**RESPONSE TO COMMENTS FROM
NEW YORK STATE DEPARTMENT OF ENVIRONMENTAL CONSERVATION
FOR VANADIUM CORPORATION OF AMERICA
SITE NO. 932001, OU NO. 2 AIRCO PROPERTIES
INTERIM REMEDIAL MEASURE REPORT,
WITMER ROAD LANDFILL, NIAGARA FALLS, NEW YORK**

COMMENTOR: Michael Hinton

DATED: 12 January 2001

CAP TERMINATION DETAIL 'A'

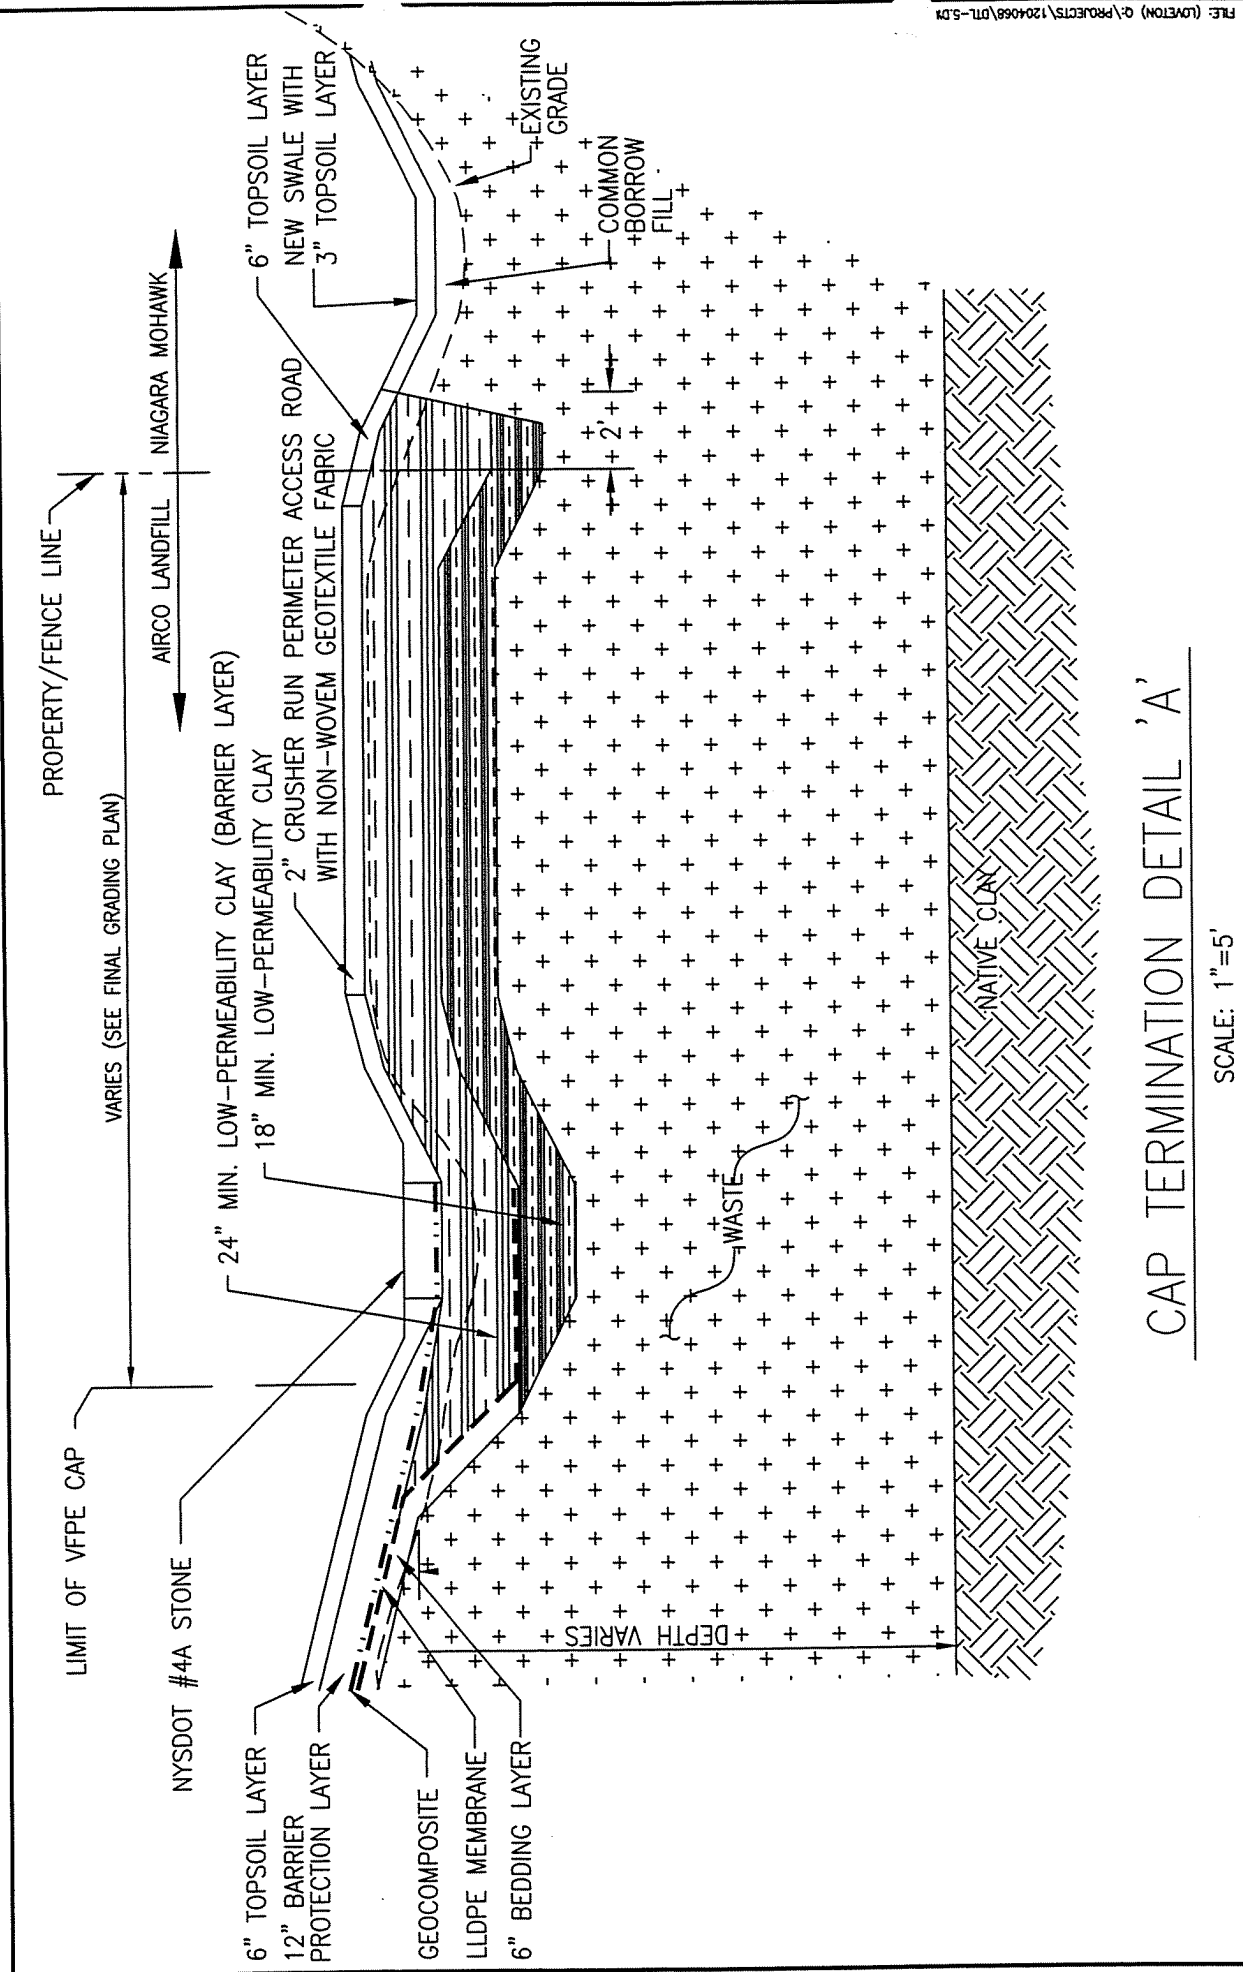
14. **Figures 4 and 5**—Indicate geo-textile fabric under perimeter access road, add notes for topsoil layers and correct arrow for the common fill. Show distance from fence to edge of clay in Figure 5.

Response—Comment noted. The geotextile fabric has been denoted on both figures. The distance to clay, common borrow notation, and topsoil notations has been modified as requested.

CAP TERMINATION DETAIL 'D'

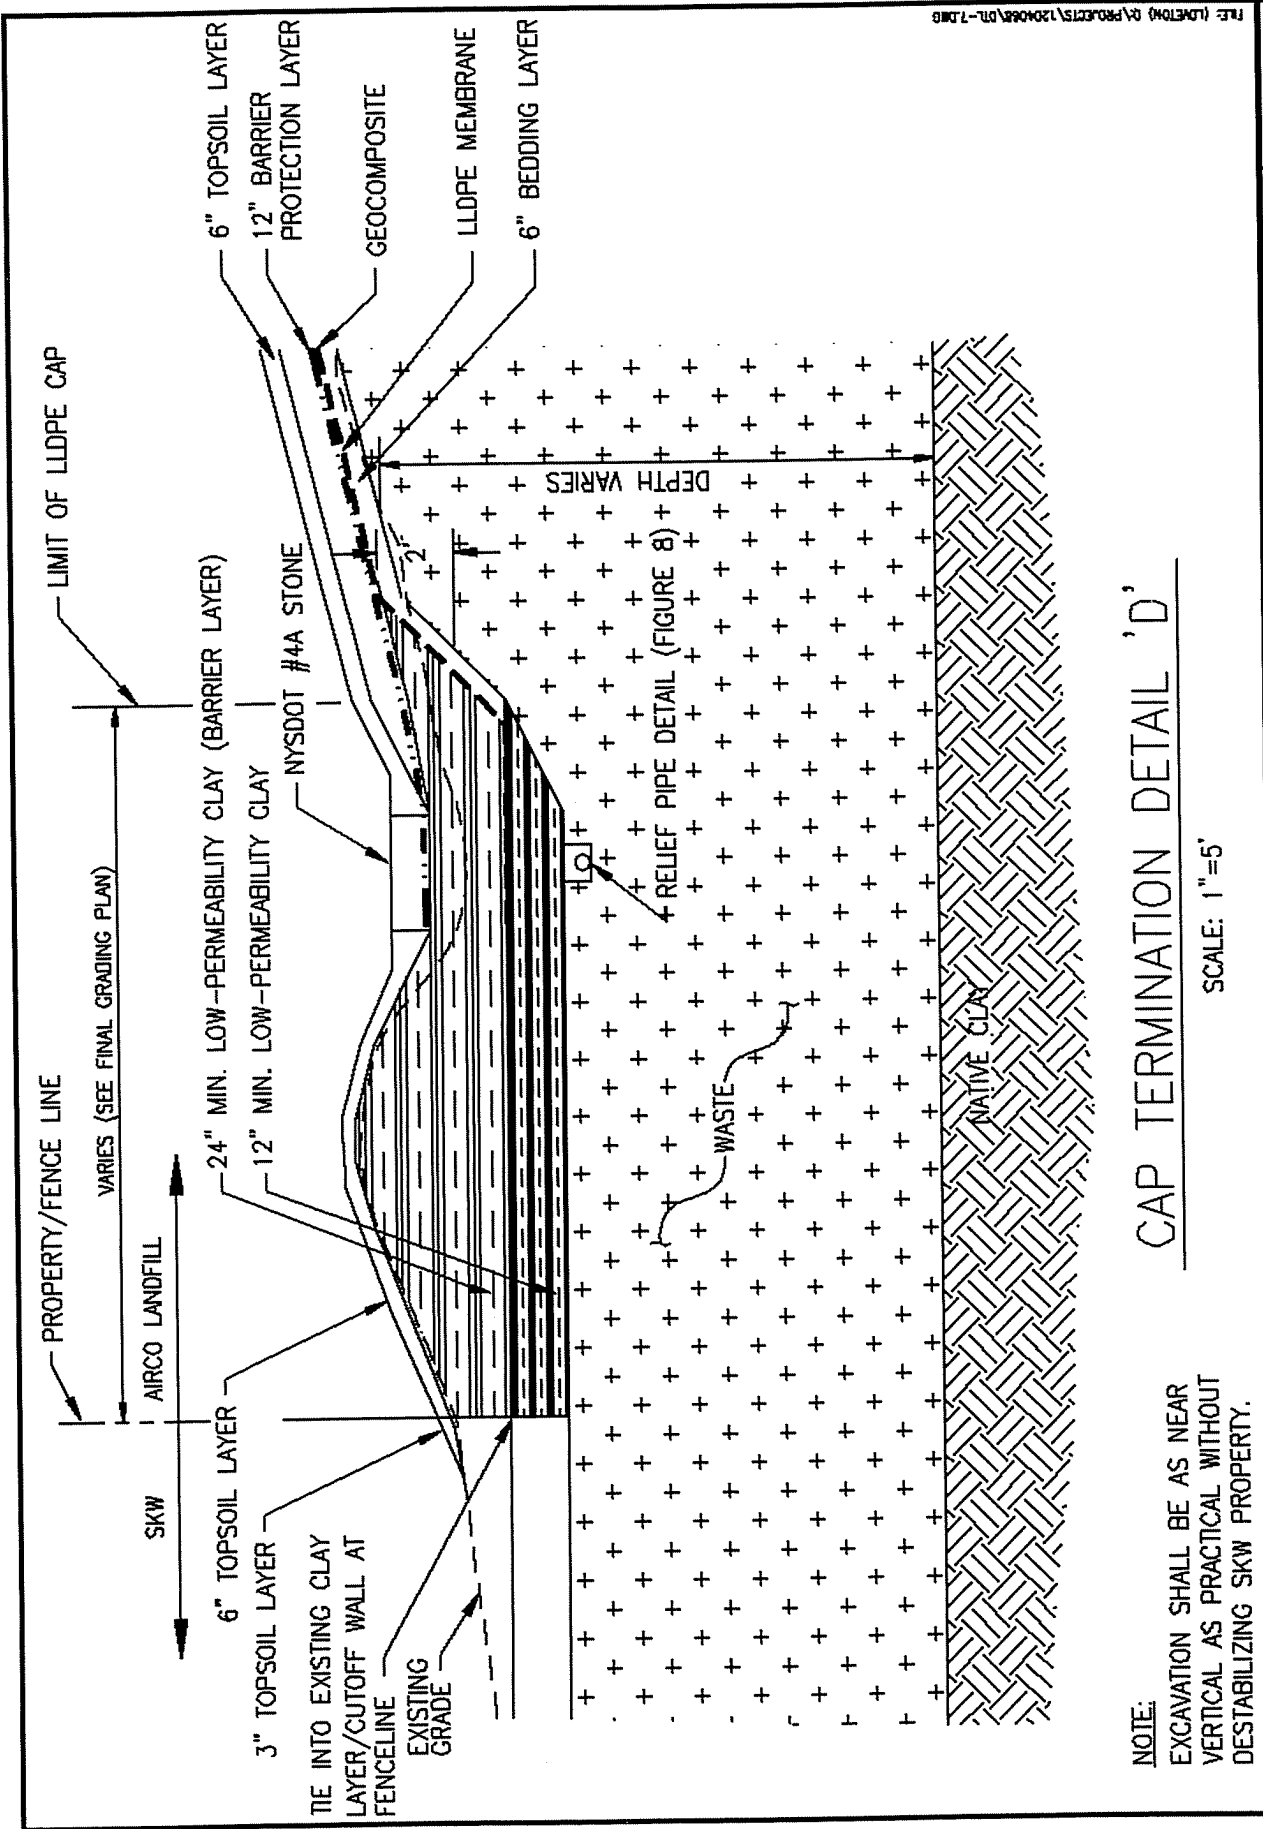
15. **Figure 6**—Label topsoil layer on left side of detail and correct relief pipe not by adding “Figure 8” to See relief pipe detail.

Response—Comment noted. The topsoil has been labeled, and the notation includes “Figure 8” when referring readers to the additional detail sheet.

| EA ENGINEERING, SCIENCE, AND TECHNOLOGY | | WITMER ROAD LANDFILL DESIGN-BUILD SITE CLOSURE NIAGARA FALLS, NEW YORK | | | FIGURE 7 PLAN VIEW RELIEF PIPE SYSTEM | | |

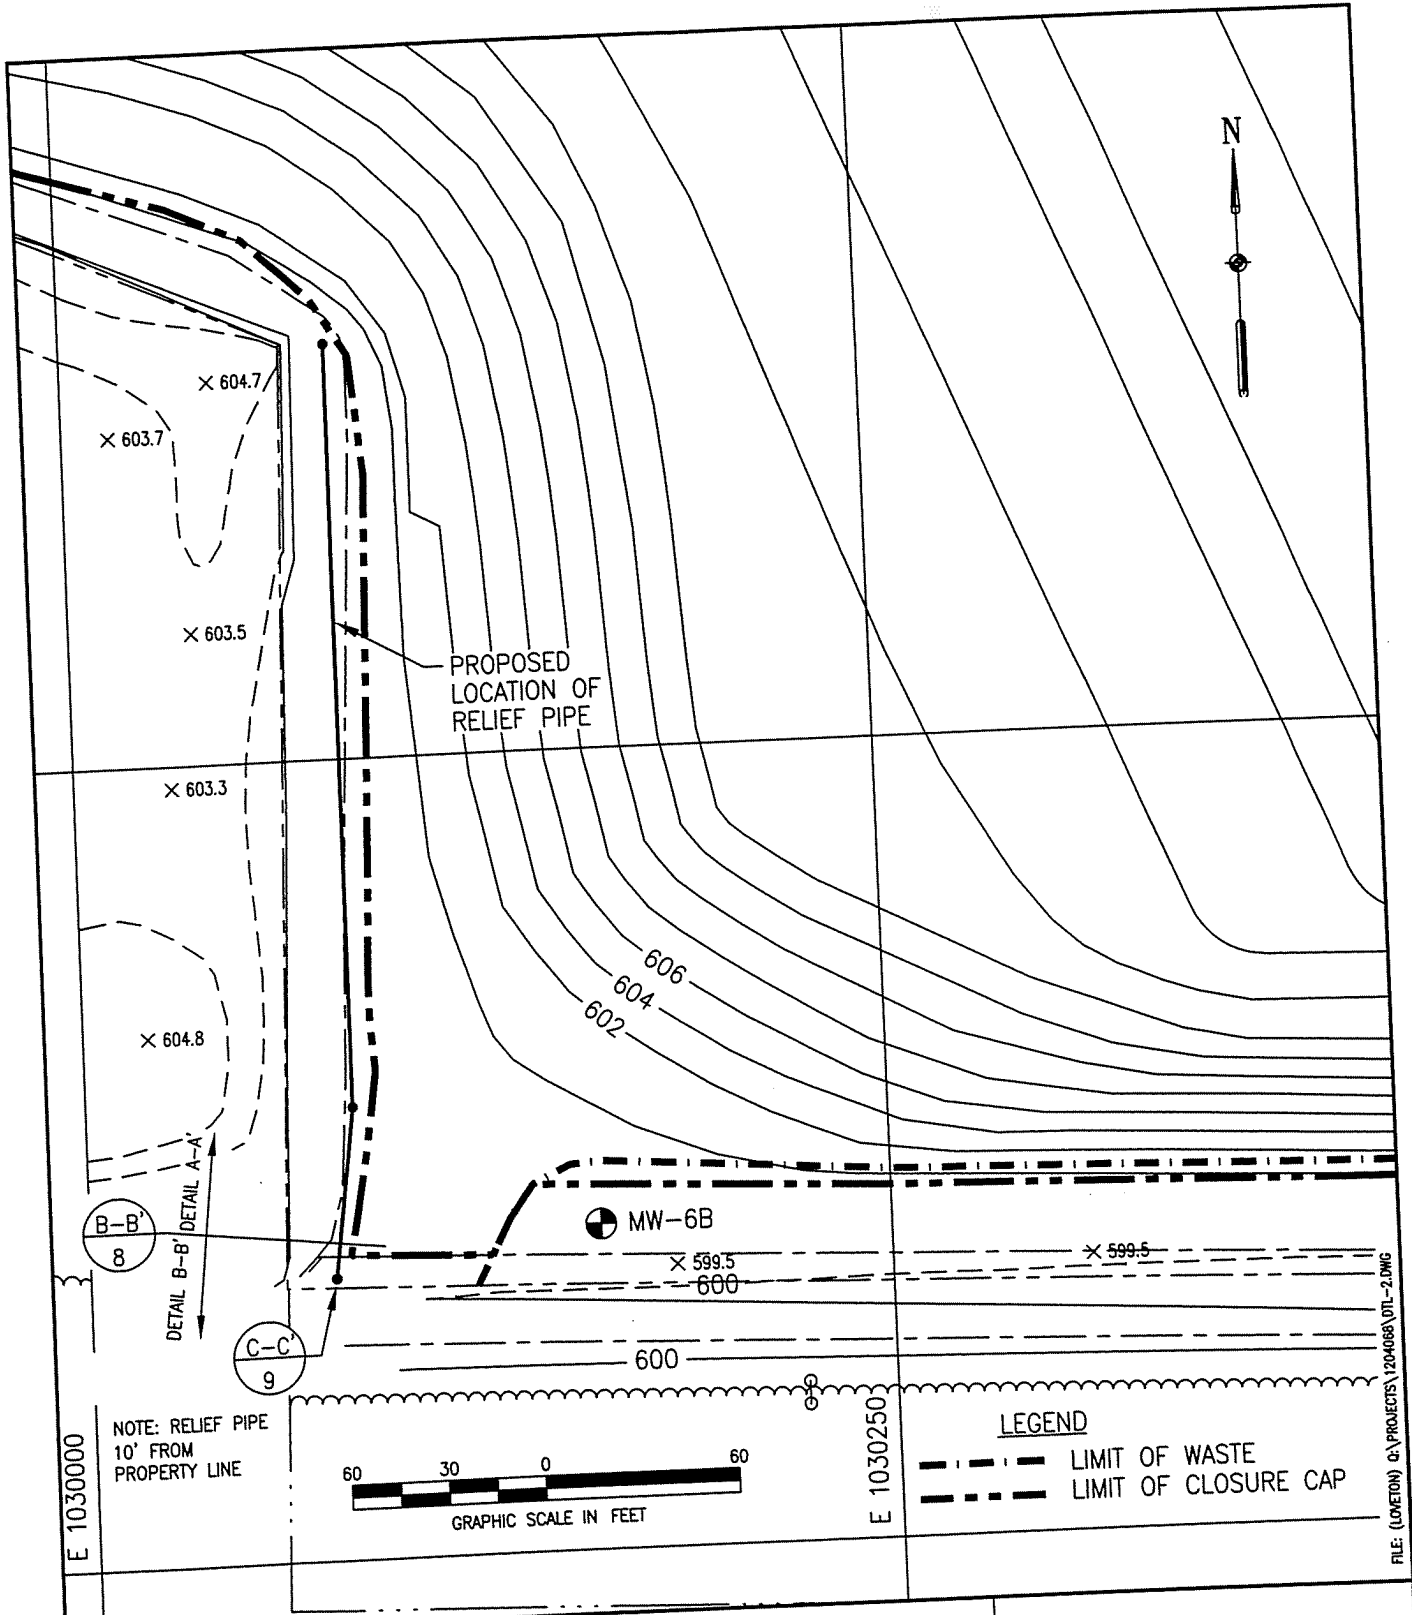
16. **Figure 7**— Indicate approximate distance from the fence line to the relief pipe and remove “proposed” from note showing pipe location.

Response—Comment noted. Proposed has been removed from the title, and the distance to the fence (approximately 10 ft) has been added.
